ADDENDUM #1:

No.	Revisions	By	Date
CITY OF WICHITA			
BR. NO. 54-87-19.05 (489) W.B.		STA. 15+612.397	
BR. NO. 54-87-19.06 (491) E.B.		STA. 15+612.397	
CIRCULAR WALL DETAILS			
MAIZE ROAD			
SEDGWICK COUNTY			
Professional Engineering Consultants, P.A.			
303 S. TOPEKA • WICHITA, KANSAS 67202 316-262-2691 • FAX 316-262-3003			
Designed by	RWA	Checked by	RAS
Drawn by	DRP	Date	April, 2002
		Job No.	97362

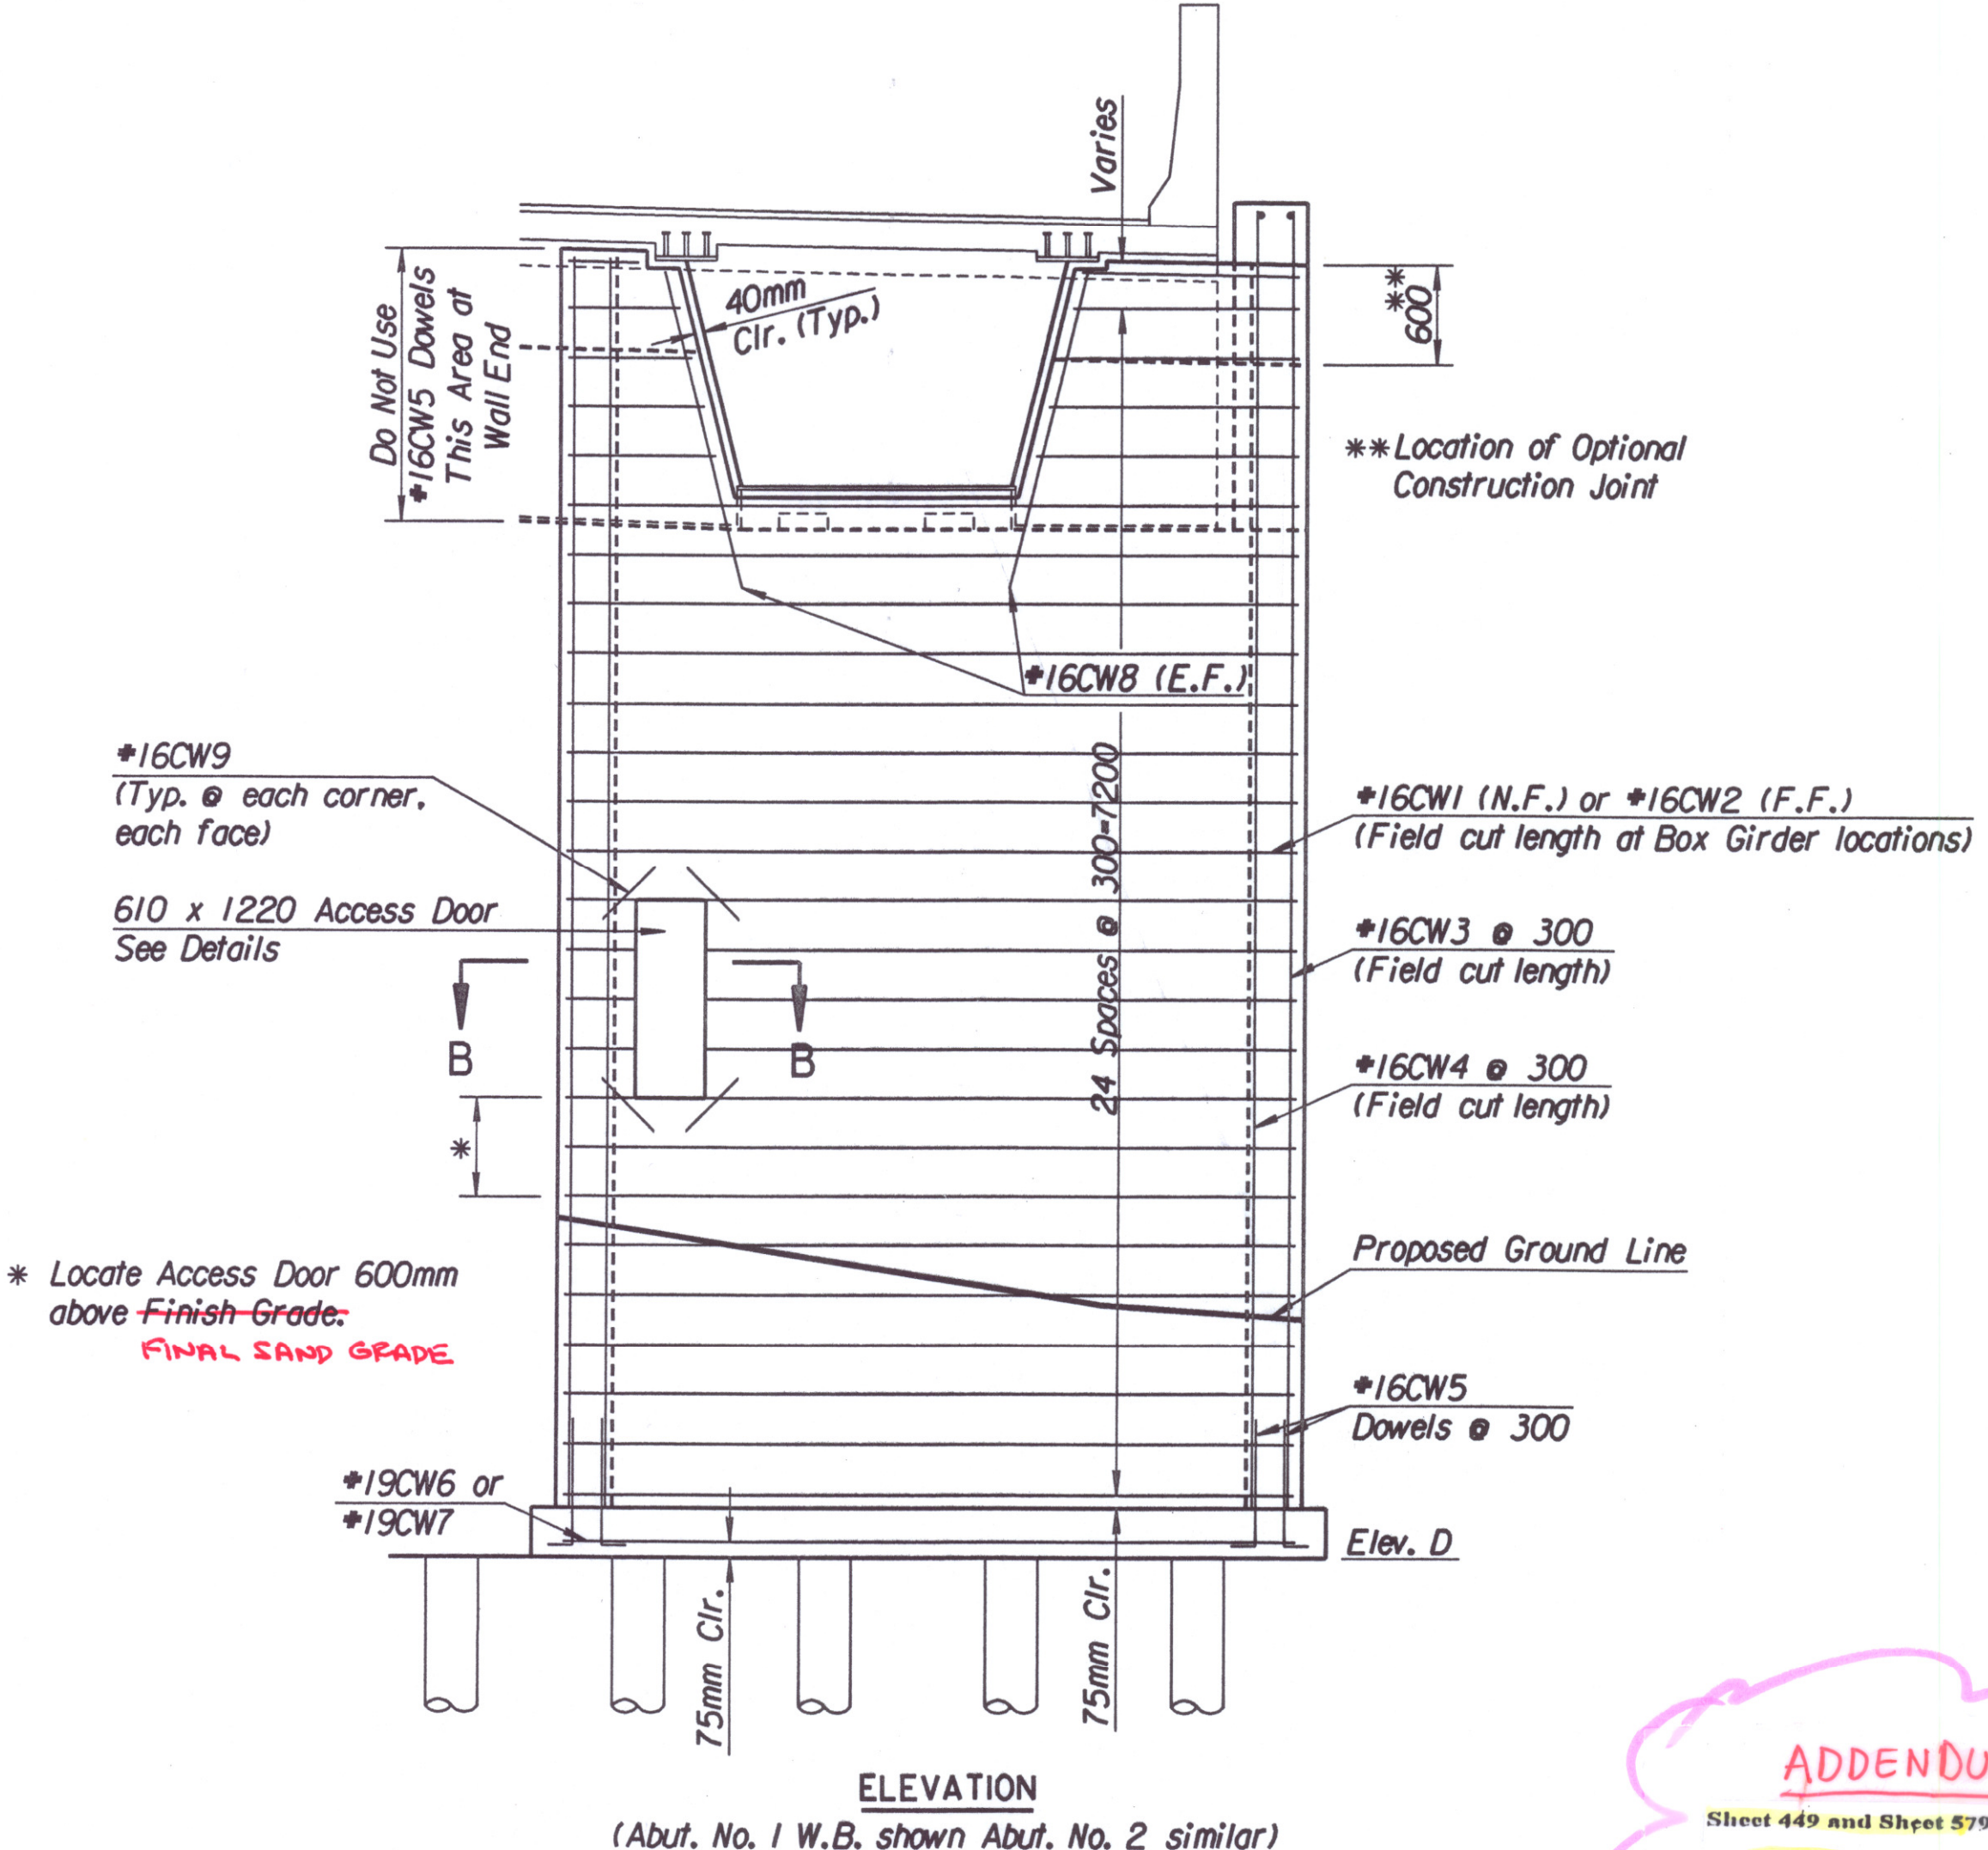
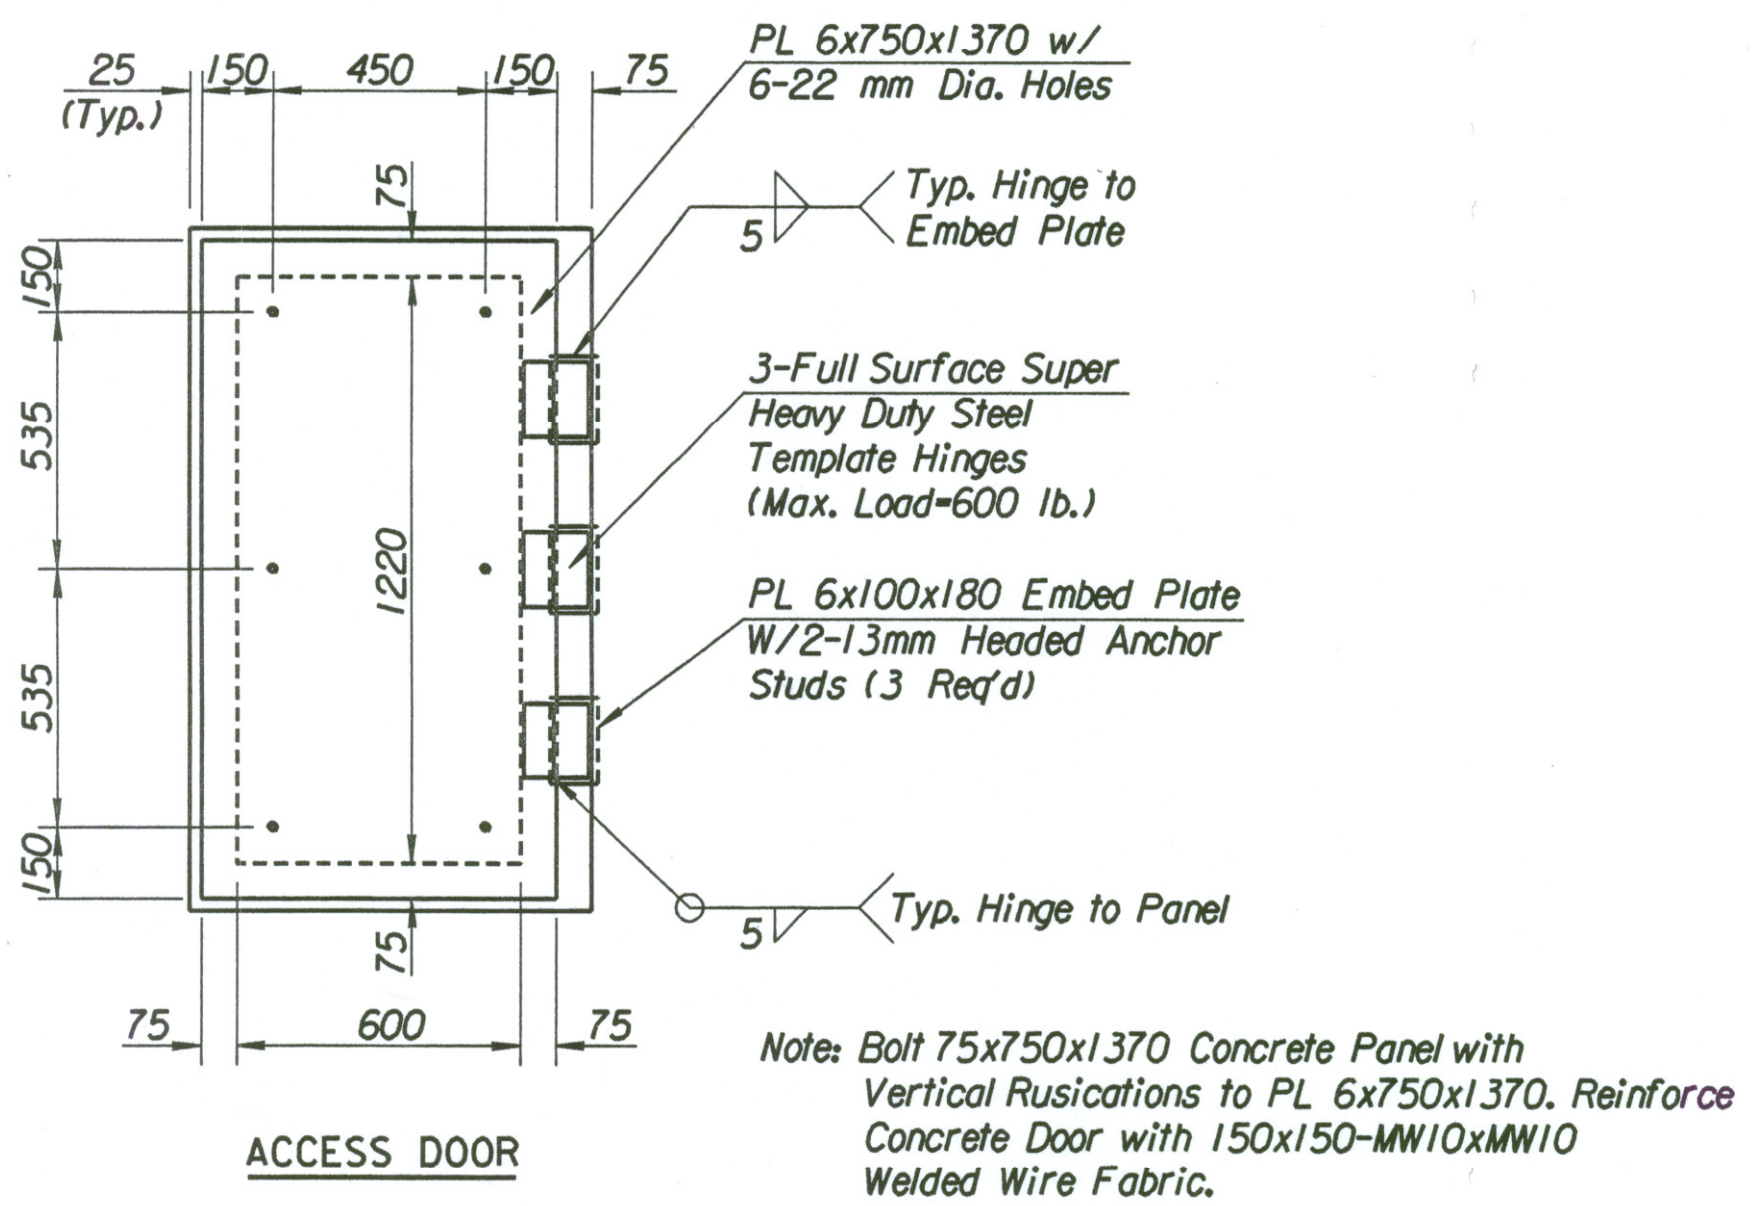
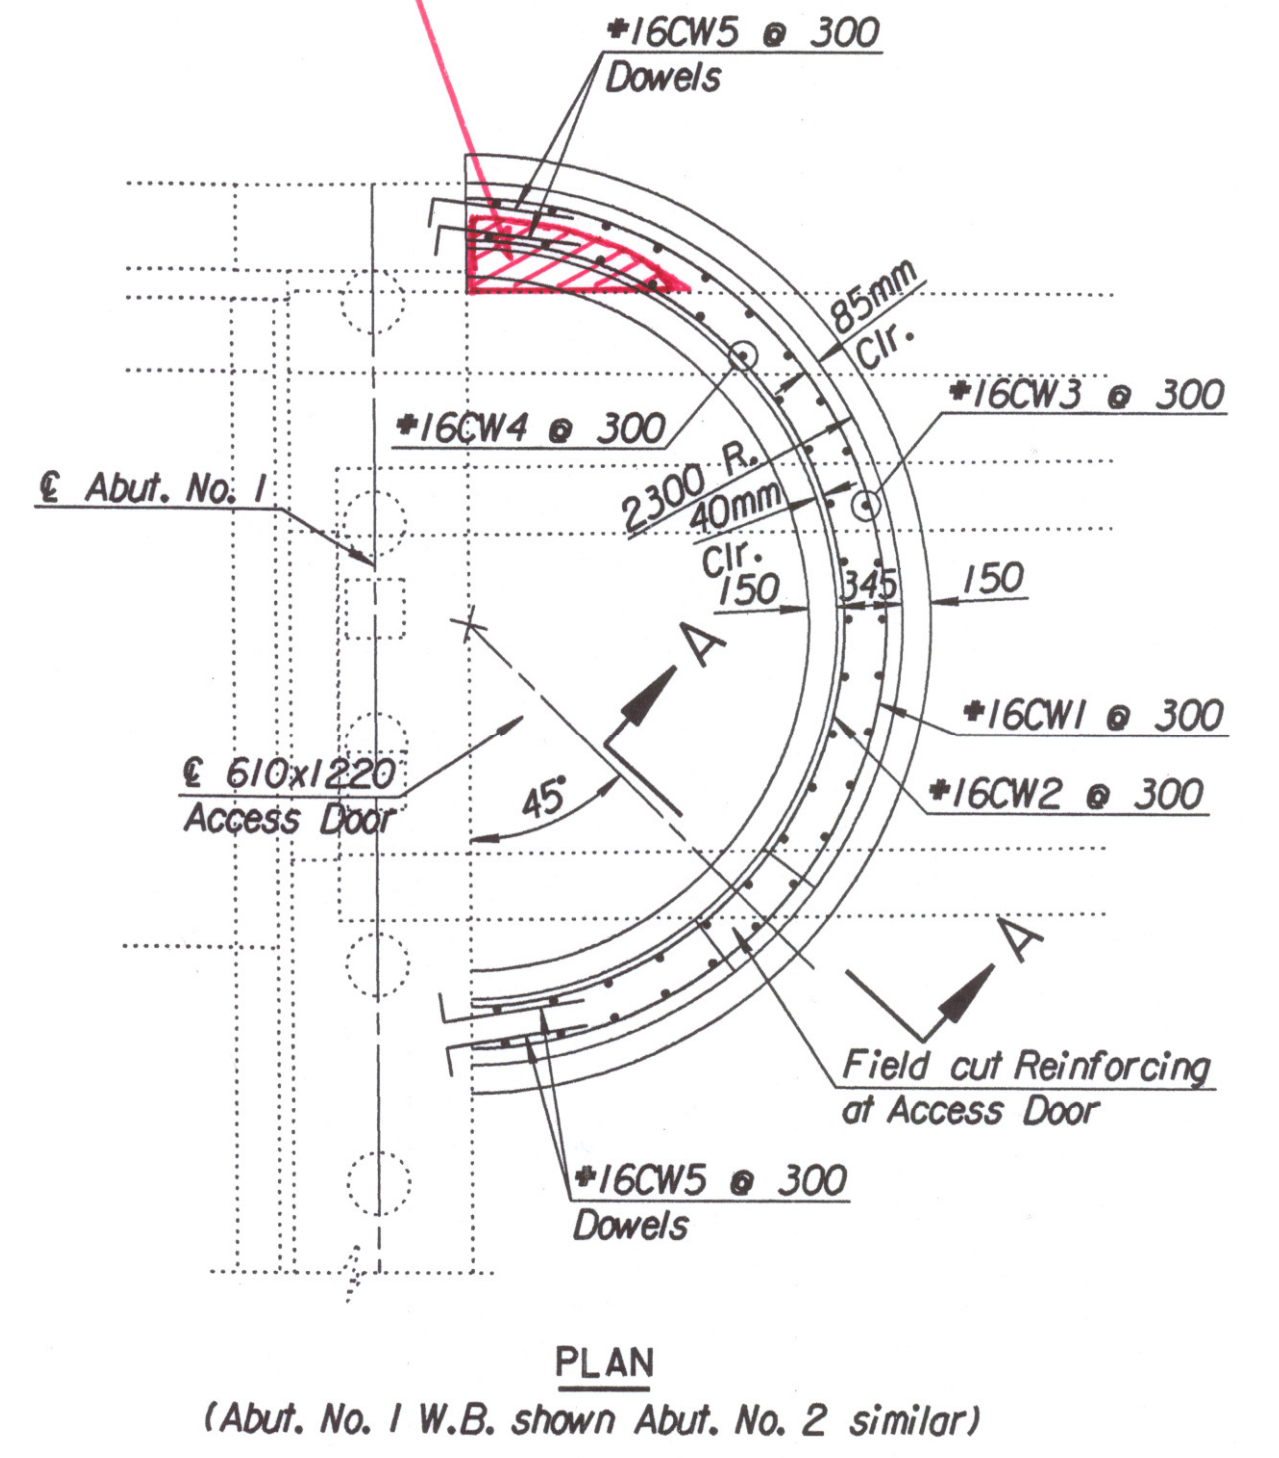
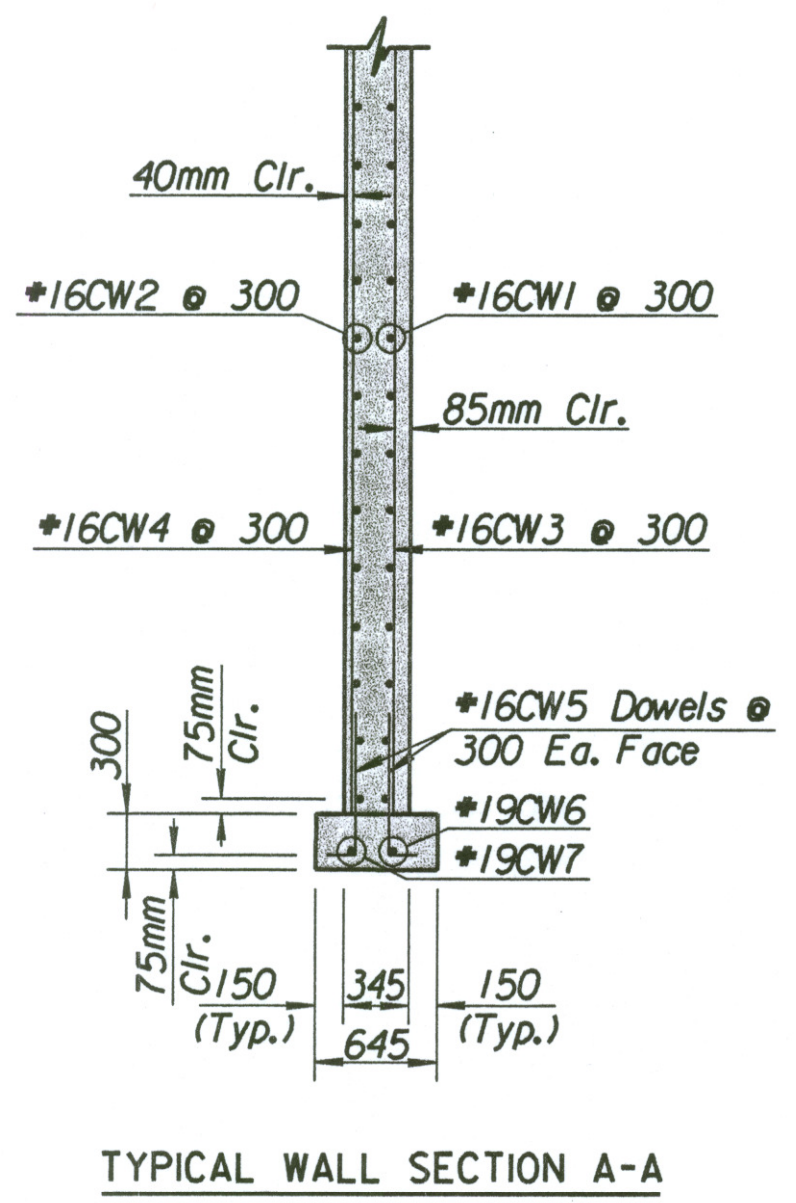
Bridge contractor field fitted and attached an angled, galvanized metal strip to cover exposed opening at top of semi-circular room to restrict excessive moisture gaining access to room. Metal strip was attached with screws and sealing compound in a manner that allowed some flexibility of metal strip during bridge structure movement. One (1) metal strip attached per semi-circular room location [four (4) total]. See Field Order 6-14-04.

Sheet 449 and Sheet 579. Add the following notes:

1. The exterior exposed face of the circular walls including the access door shall be a smooth textured surface and finished with the "Surface Coating Finish" in accordance with the specifications. Circular walls shall be measured and paid for at the unit price bid for "Concrete (Grade 30)(AE) and Reinforcing Steel(Cr. 420). Quantities are included in the Substructure Quantities.

~~Access Door at Circular Wall locations is subsidiary to bid item Reinforced Concrete Circular Walls. Quantities for Circular Walls are listed in the Substructure Quantities on the General Notes sheets. No deductions in Concrete and Reinforcing were made for Access Door openings.~~
